## CUSTOMER REQUIREMENT CHECK LIST

COMPANY NAME : PT. Advanex  
PIC : Mr. Yayat  
PHONE/FAX NO. :  
E-MAIL :

## STANDARD PACKAGING

**QUALITY CONFIRMATION**

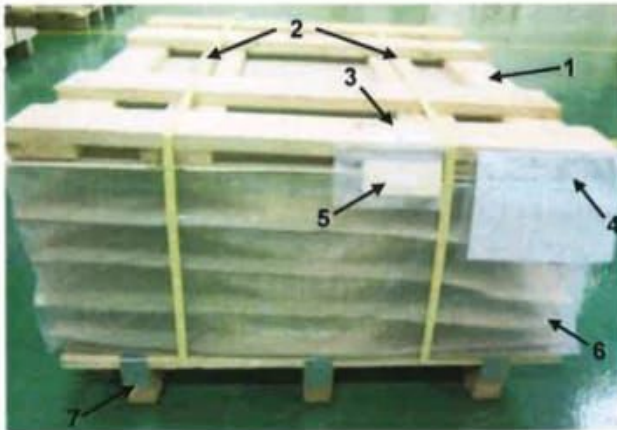
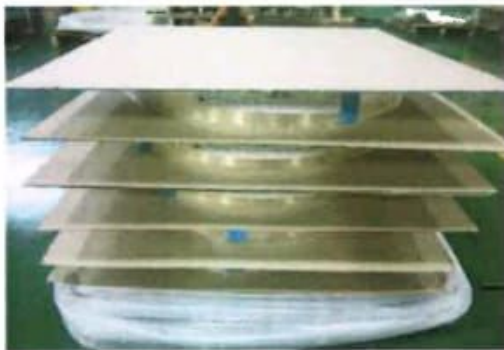
STANDARD PACKAGING "OK", PASTIKAN DALAM 1 PALET TIDAK UNTUK BEBERAPA TIPE, 1 PALET 1 TIPE.
